# A47 Wansford to Sutton Dualling

### **Appendix 13.2 – Drainage strategy report**

A47 Wansford to Sutton  
Development Consent Order 202[x]

<b>Regulation Number:</b>	Regulation 5(2)(a)
<b>Planning Inspectorate Scheme Reference</b>	TR010039
<b>Application Document Reference</b>	TR010039/APP/6.3
<b>BIM Document Reference</b>	HE551494-GTY-HDG-000-RP-CD-00001-C01
<b>Author:</b>	A47 Wansford to Sutton Project Team, National Highways

#### Sheet 3

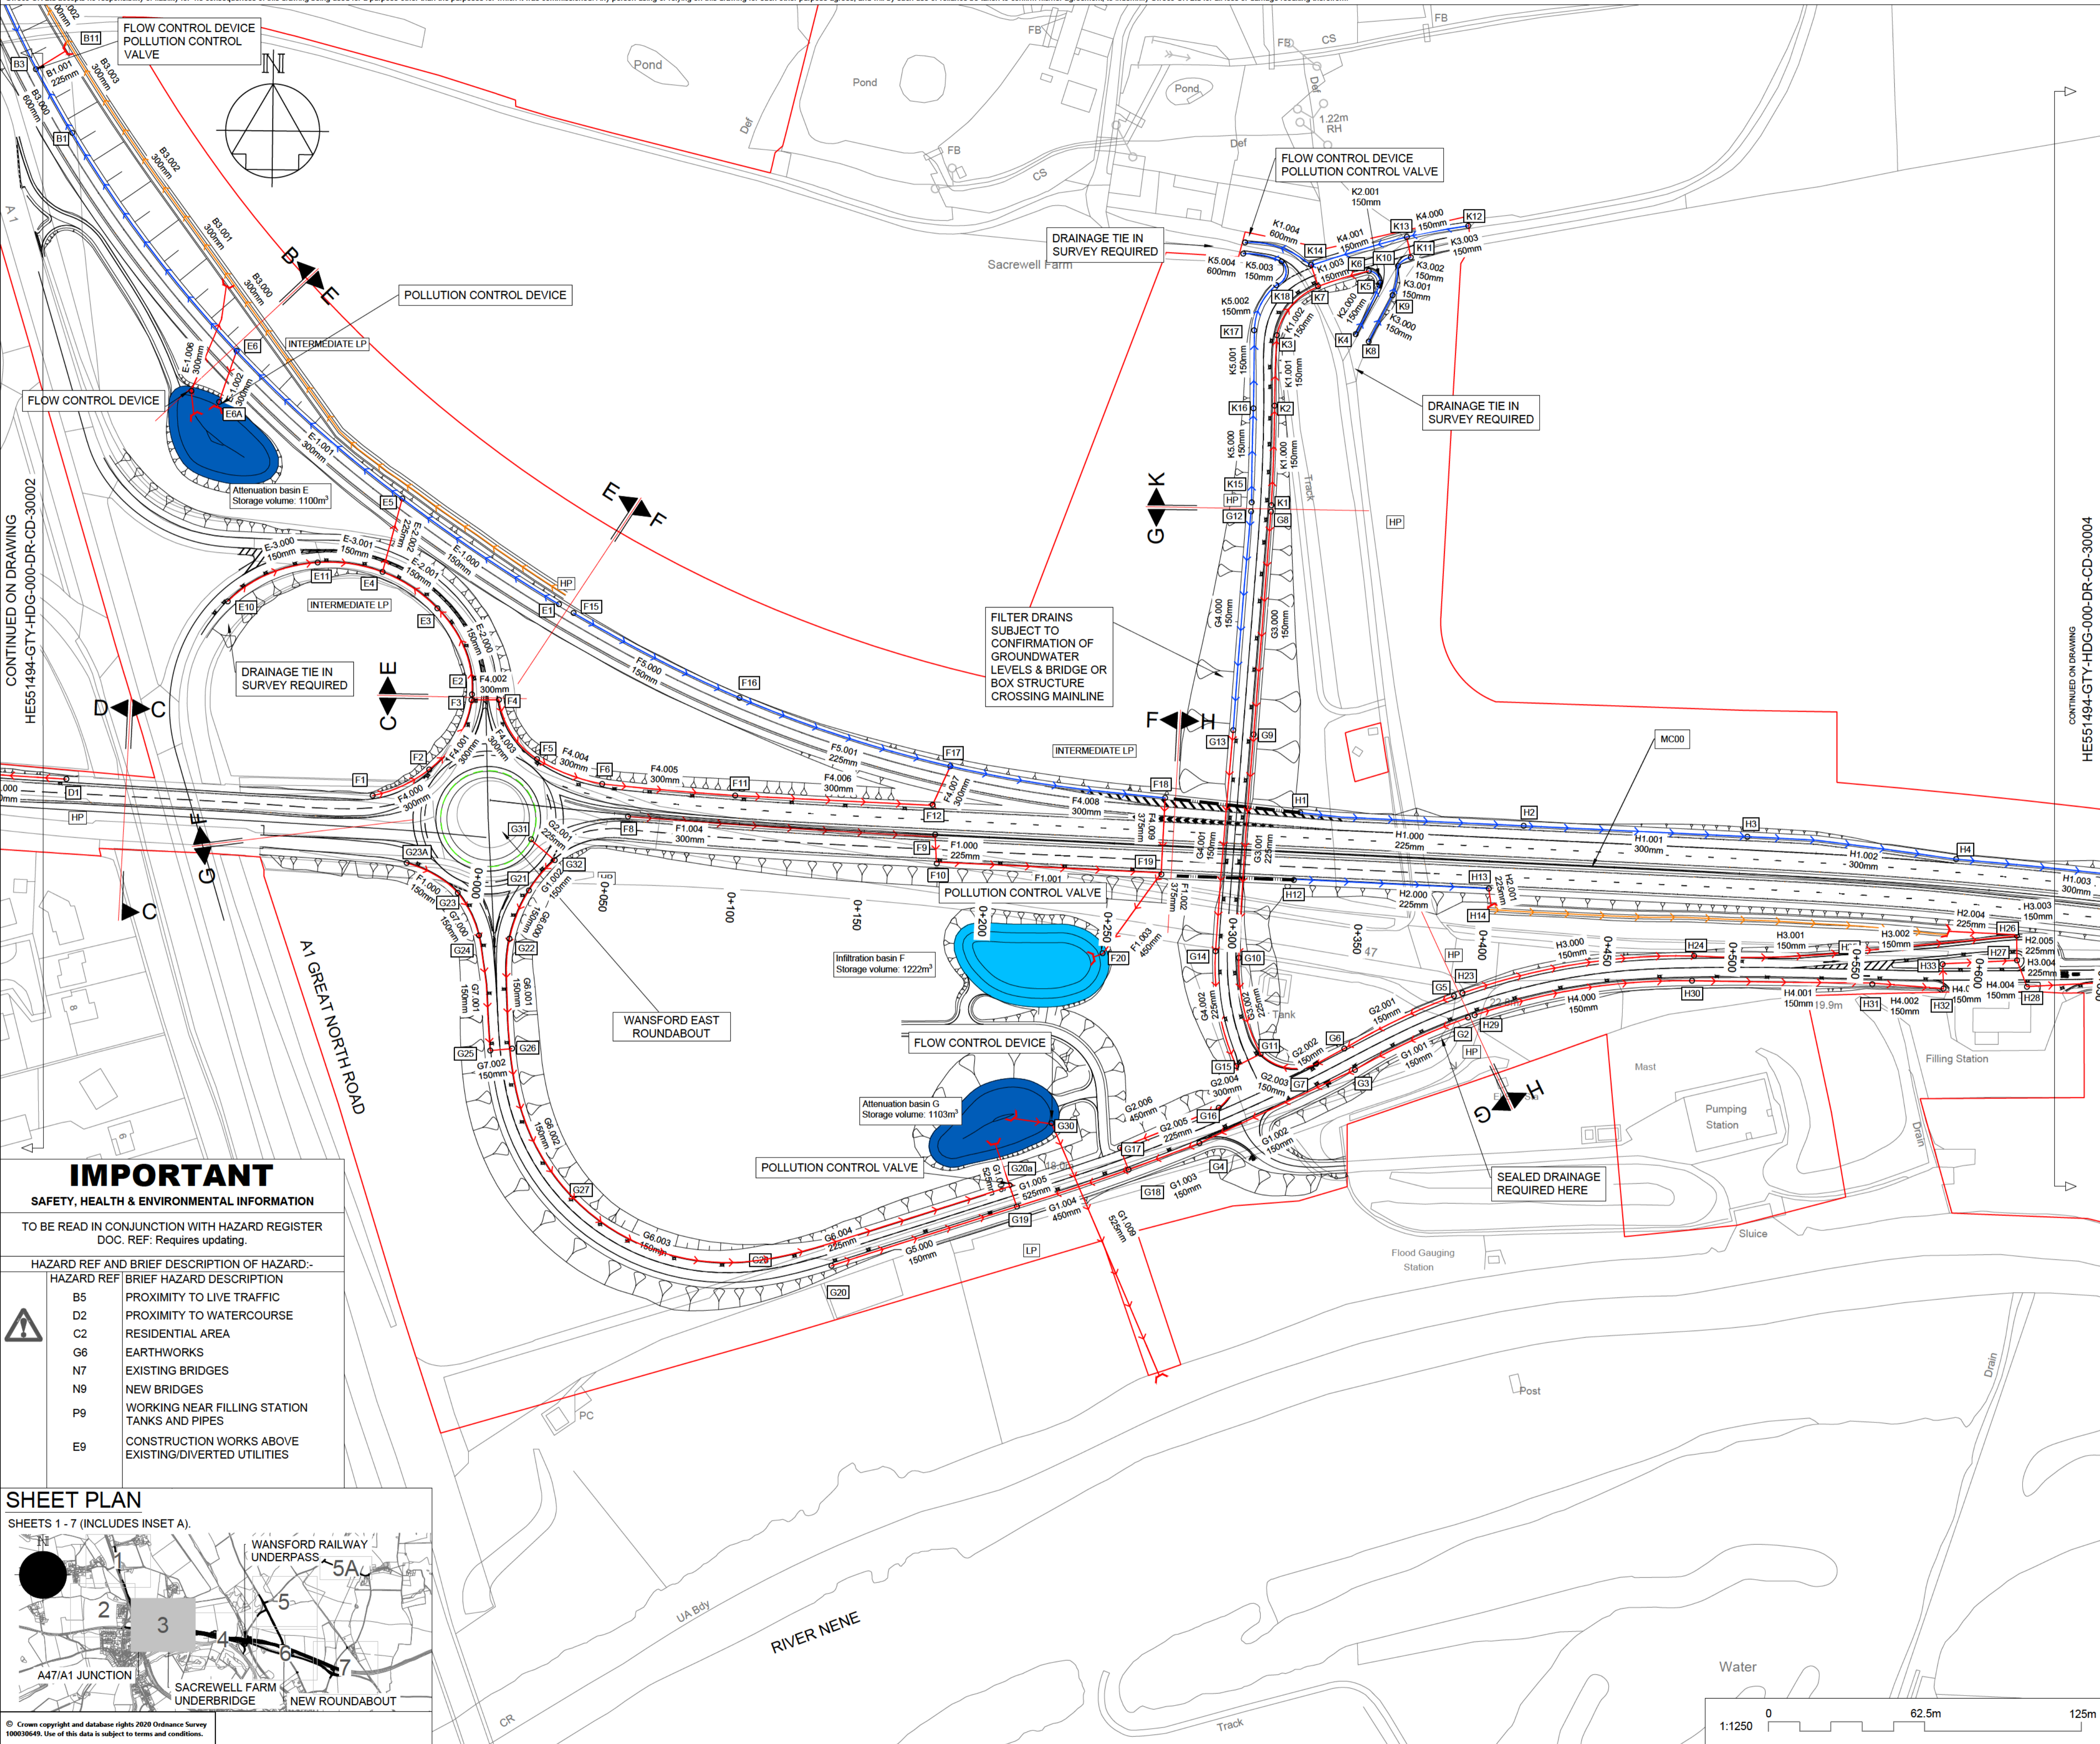
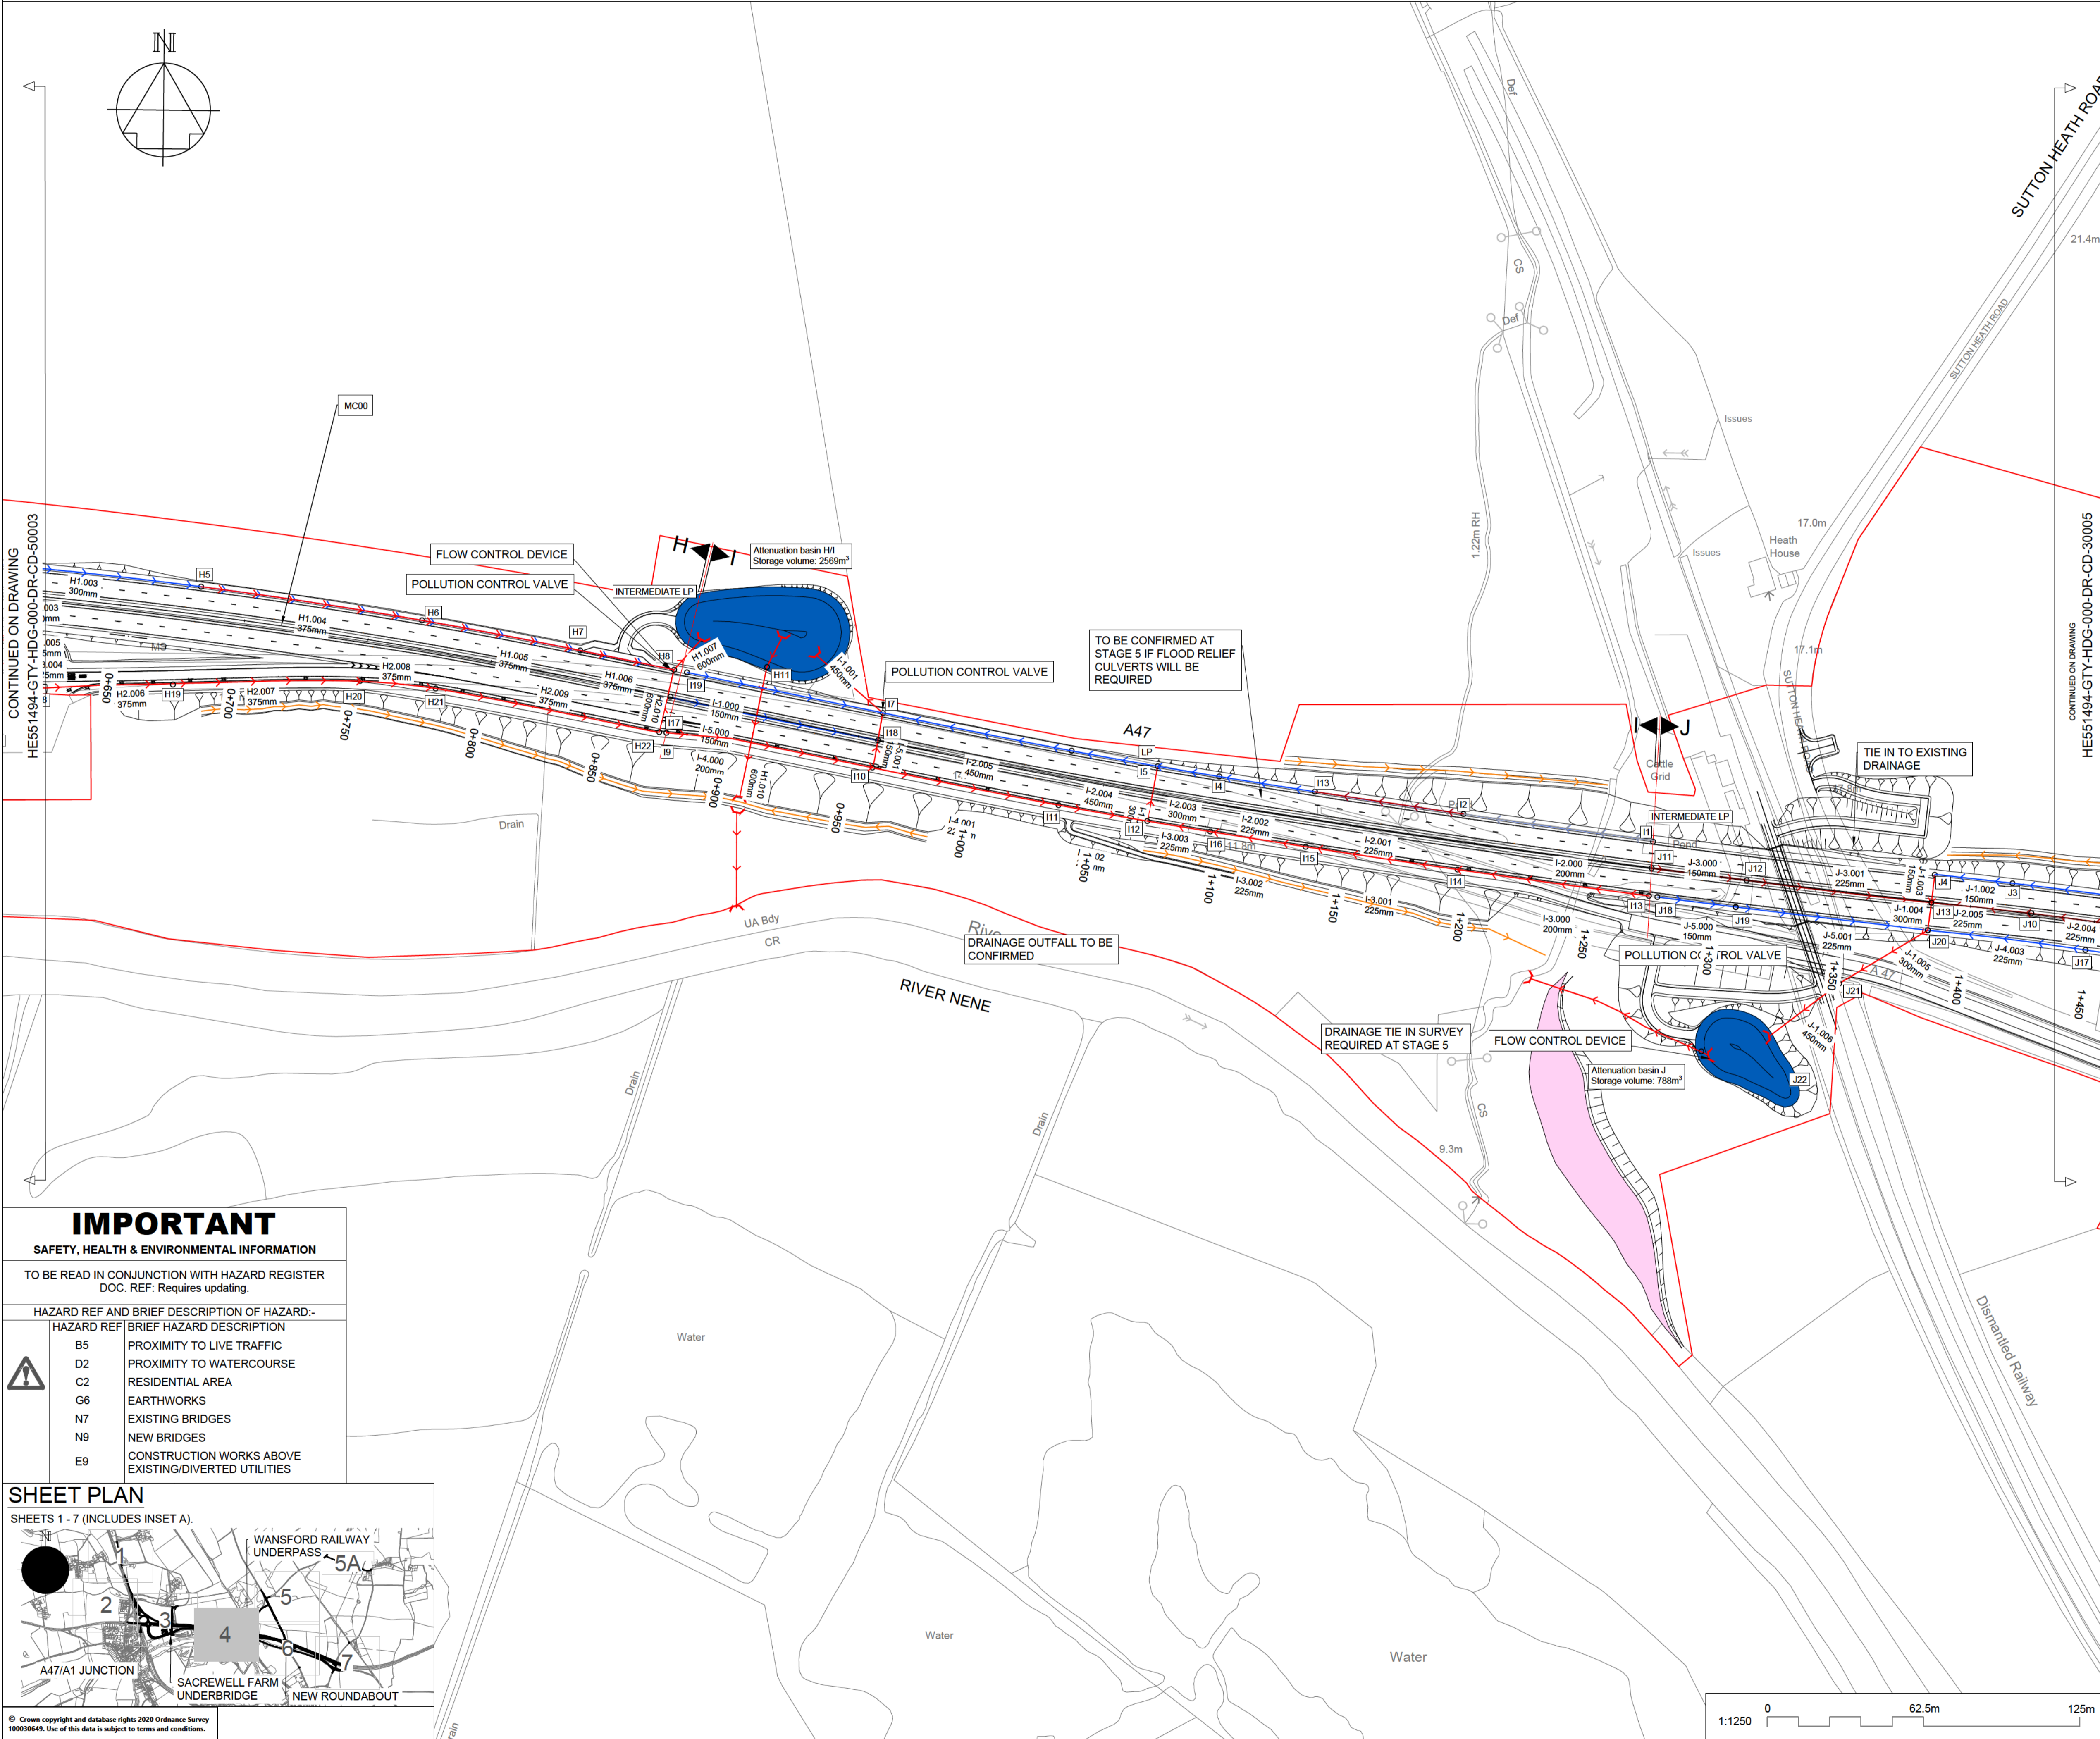
6. Network F - it appears from the drawing that the kerb drain system that serves the roundabout does not have a connection to the rest of network F. Should this be amended it would be logical to connect this to network G (F23 to G23 and F24 to G21).

**DRAINAGE LAYOUT PLAN  
SHEET 5 OF 7**

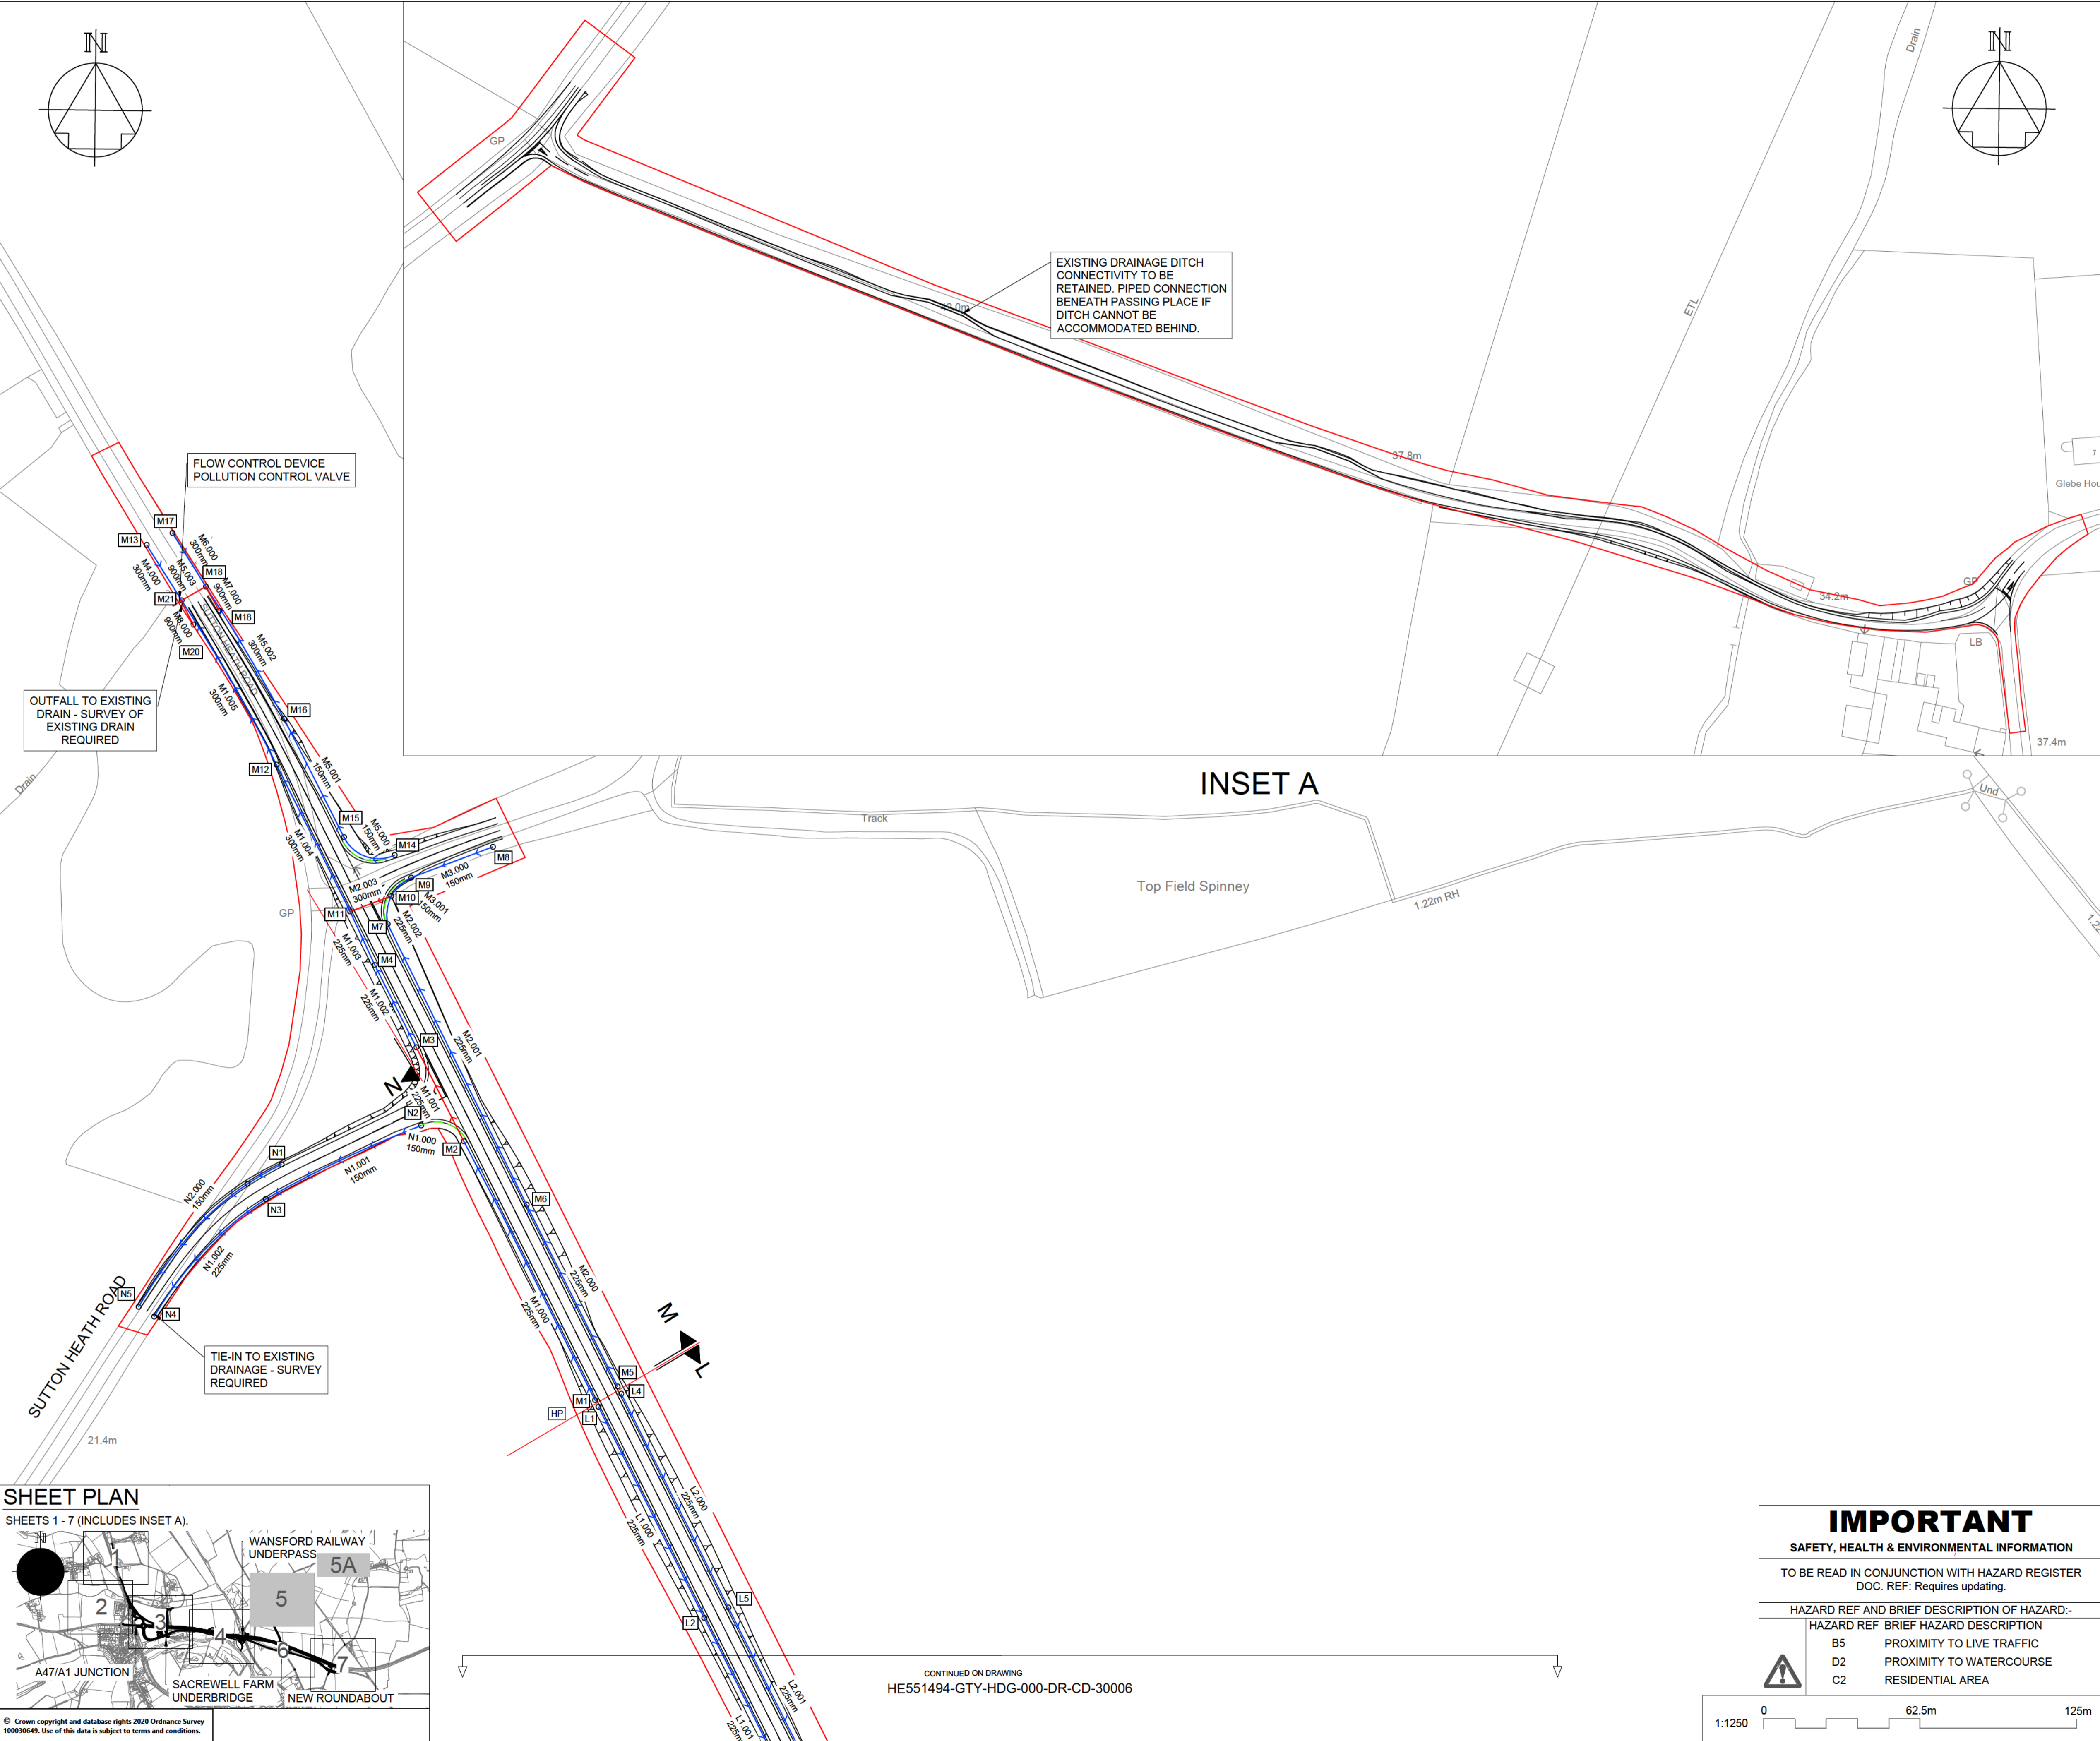
#### Sheet 5

1. Network M - In relation to the proposed outfall at manhole M21, as we understand it this existing drain is in a poor condition / now non-existent due to cattle occupying the adjacent field. As such we would be cautious of a positive system discharging into said ditch. As stated on the drawing a drainage survey will be required.
2. Network N - In relation to the proposed outfall at manhole N4, a drainage survey is required as we are not aware of any existing positive drainage system on Sutton Heath Road.
